KAWARTHA PINE RIDGE DISTRICT SCHOOL BOARD
PUR24-100-ITT
Murray Centennial Public School Addition

ADDENDUM NO. 3

Add (1): Architectural Addendum No. 2, Prepared by Moffet and Duncan Architects Inc. (34 Pages)

PARTIAL GROUND FLOOR PLAN
TEMPORARY EXITS

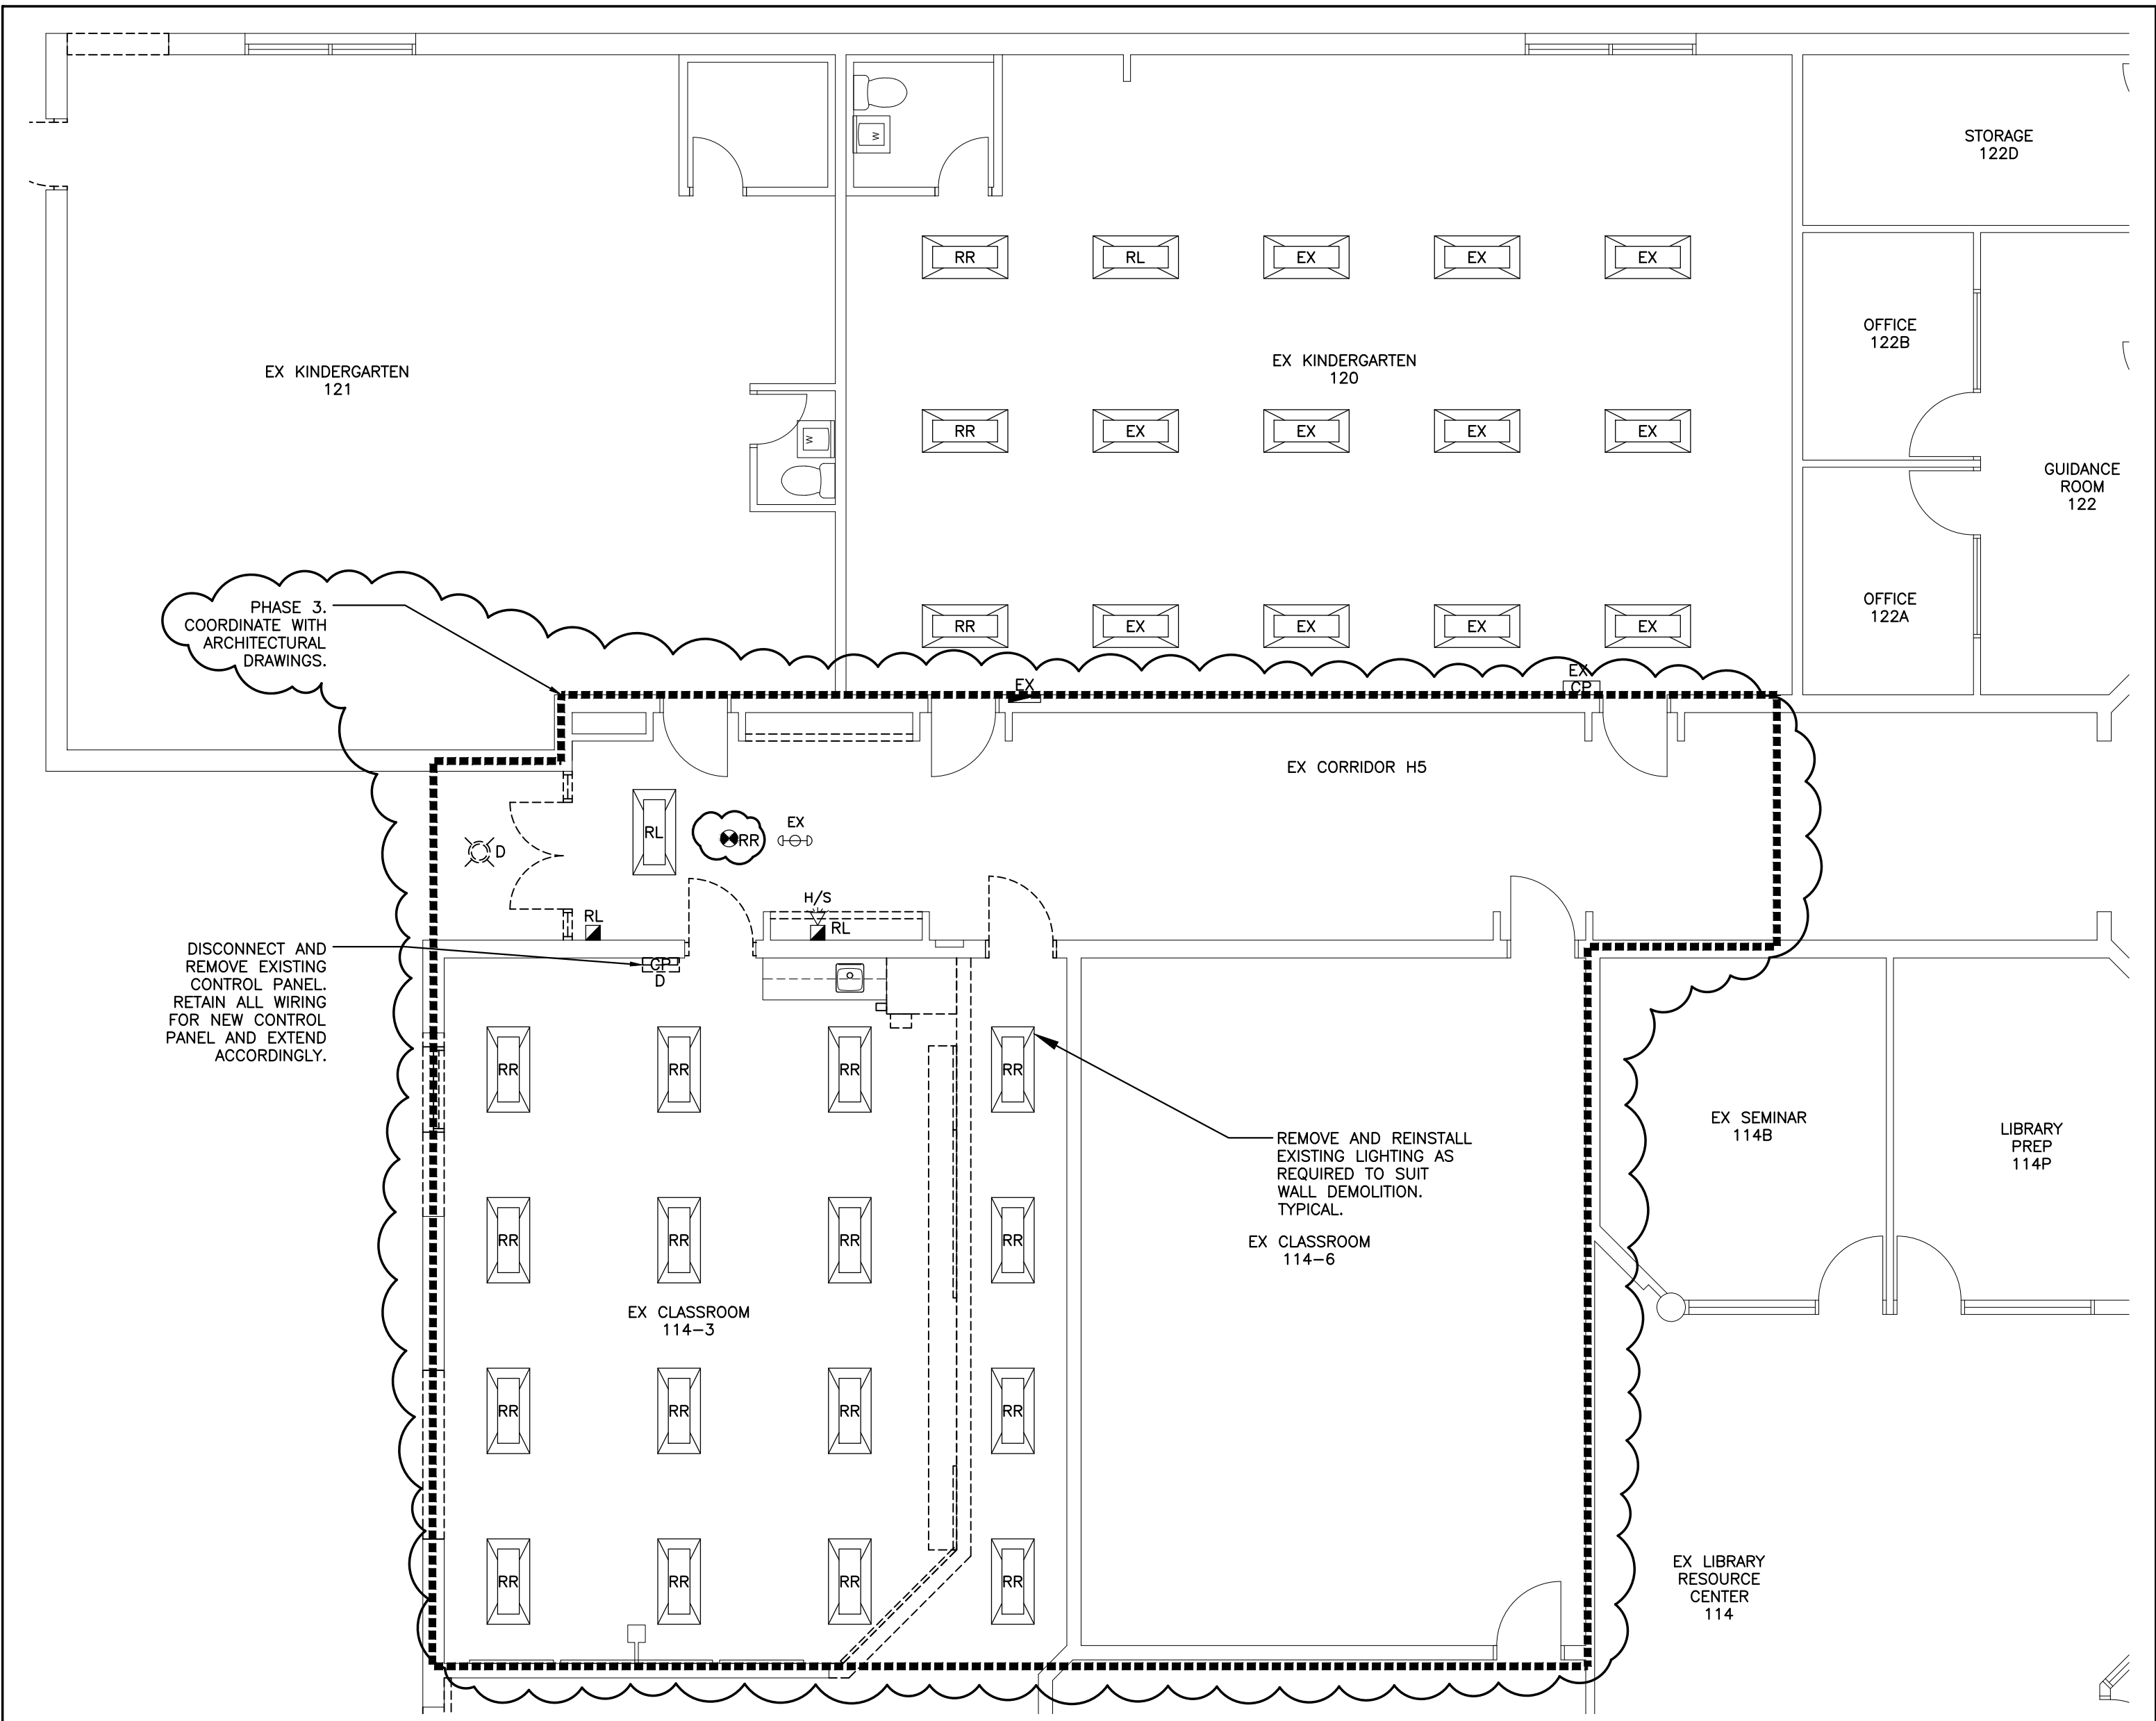
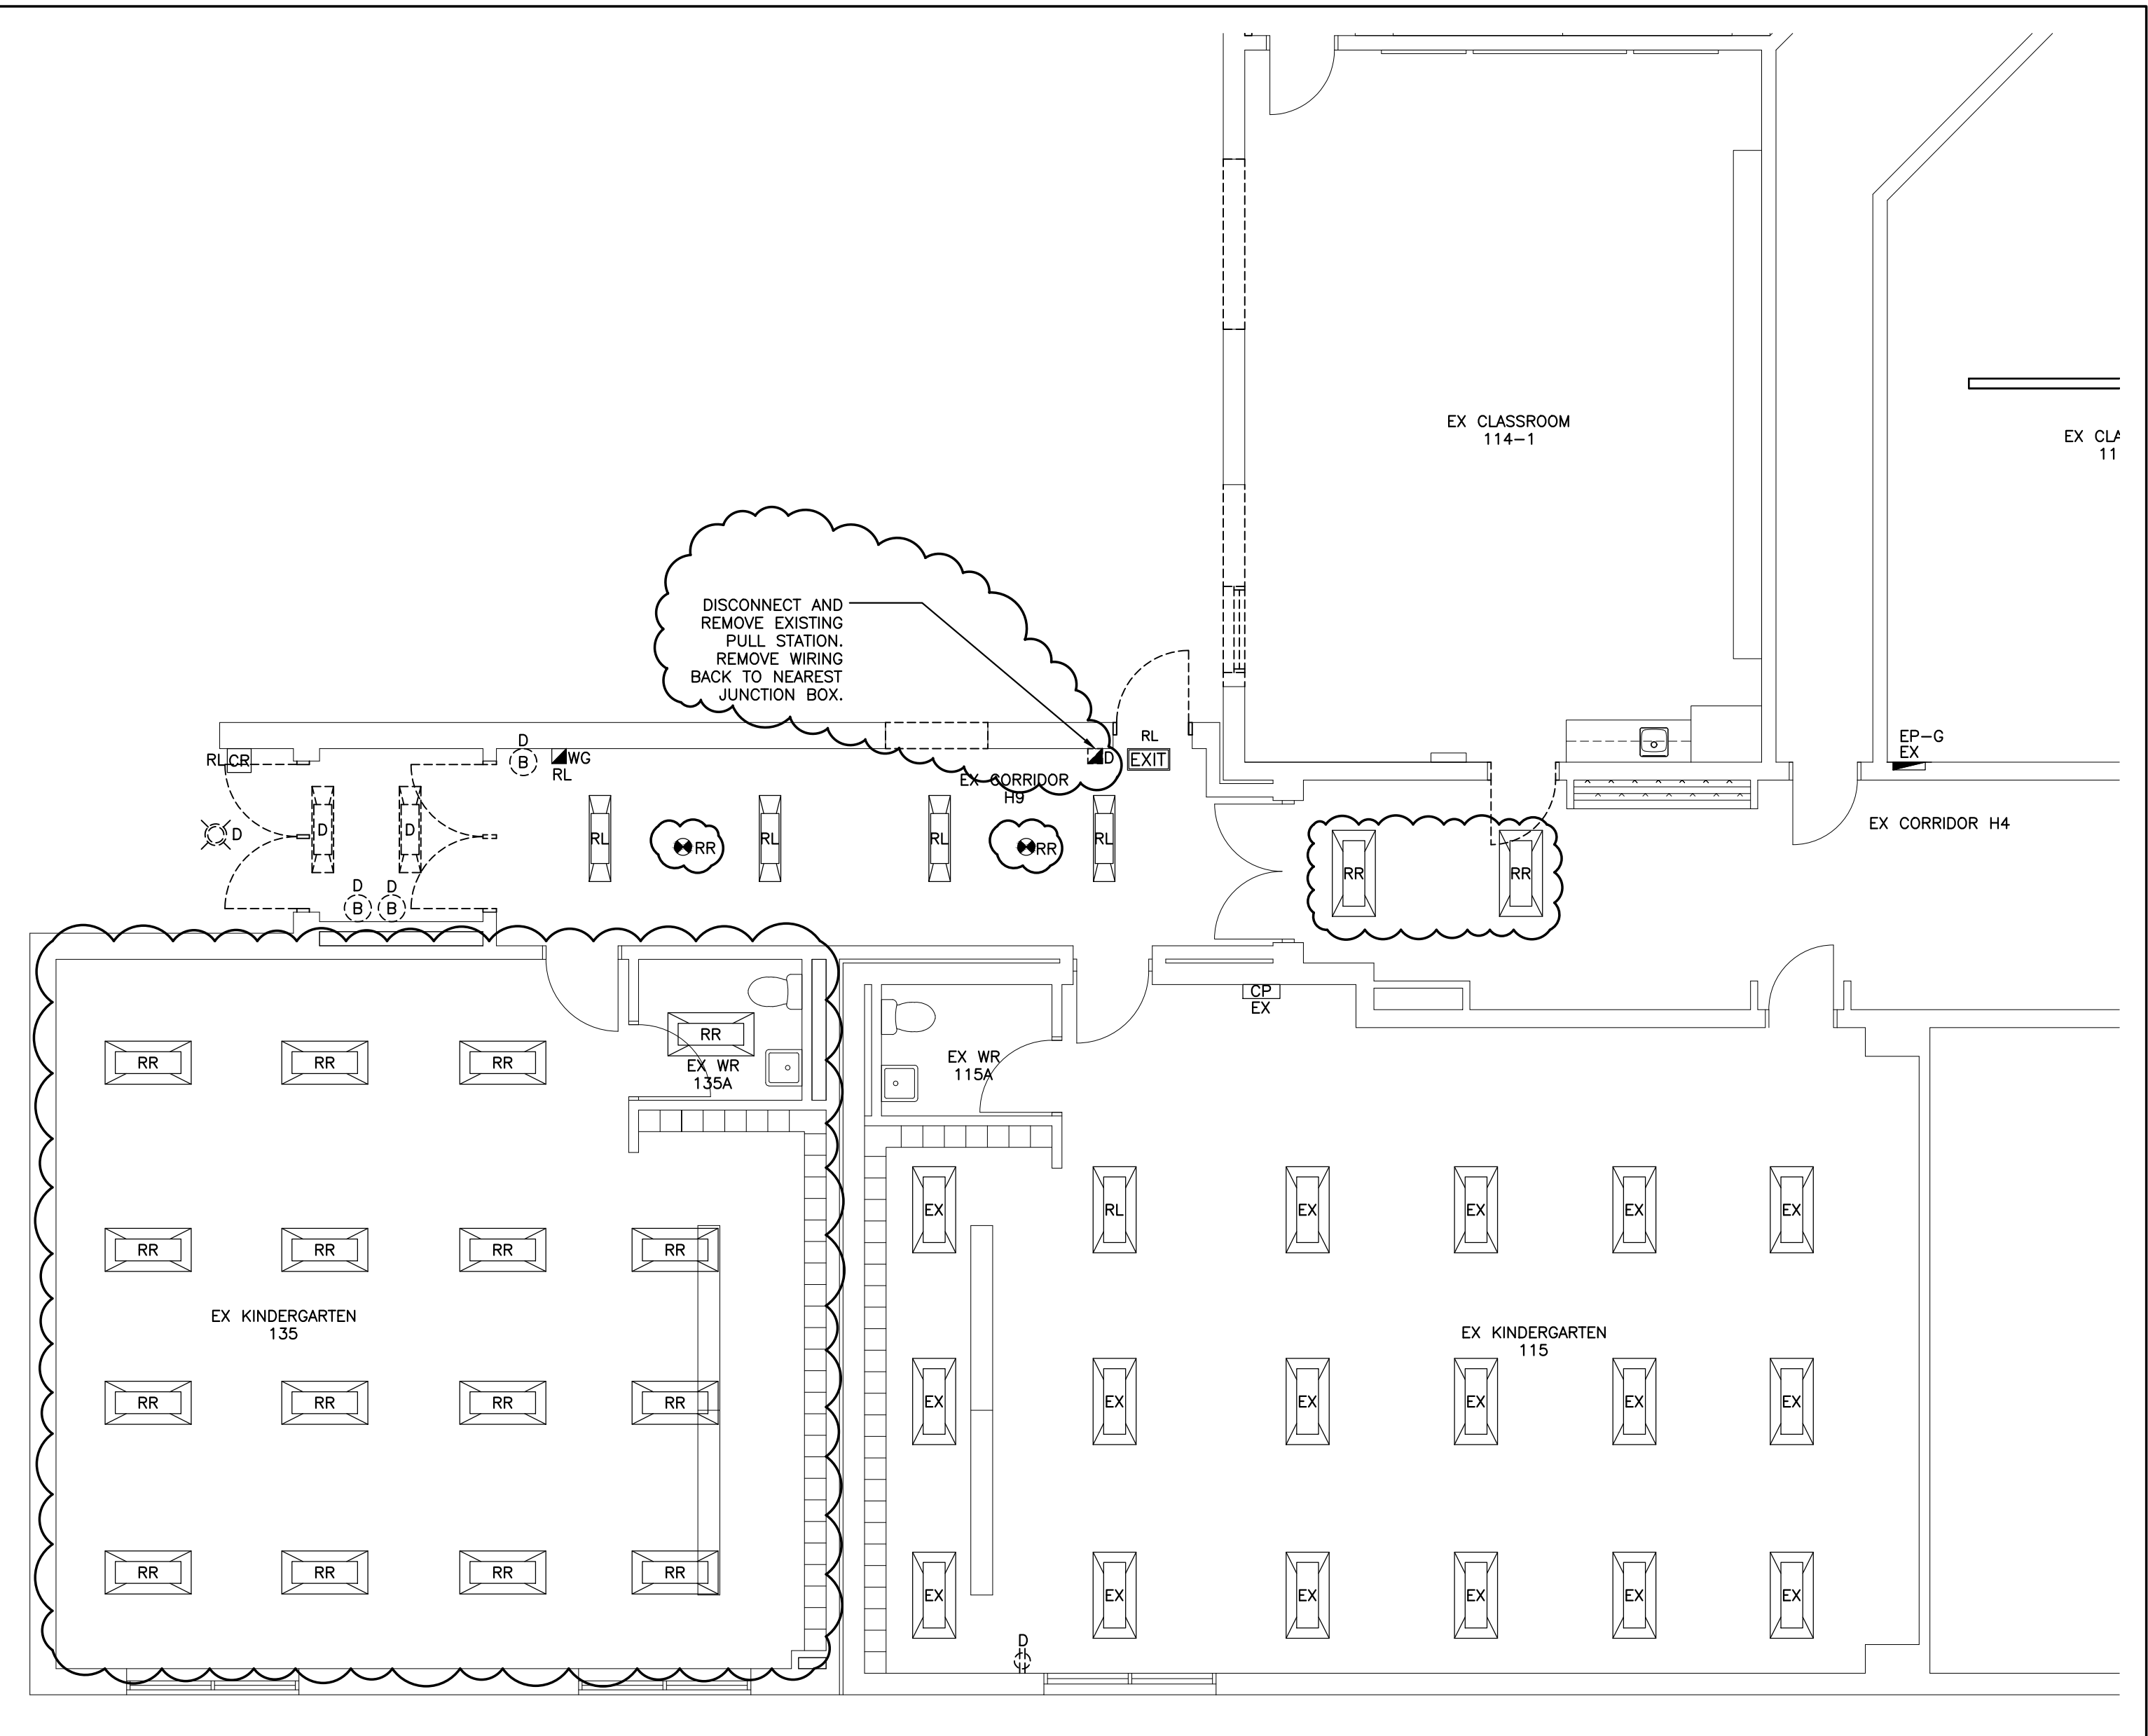
- .1 Refer to revised drawing. Work for certain areas shall be undertaken under Phase 3.
- .2 Disconnect and remove all lighting in Classroom 135 and retain for reinstallation.
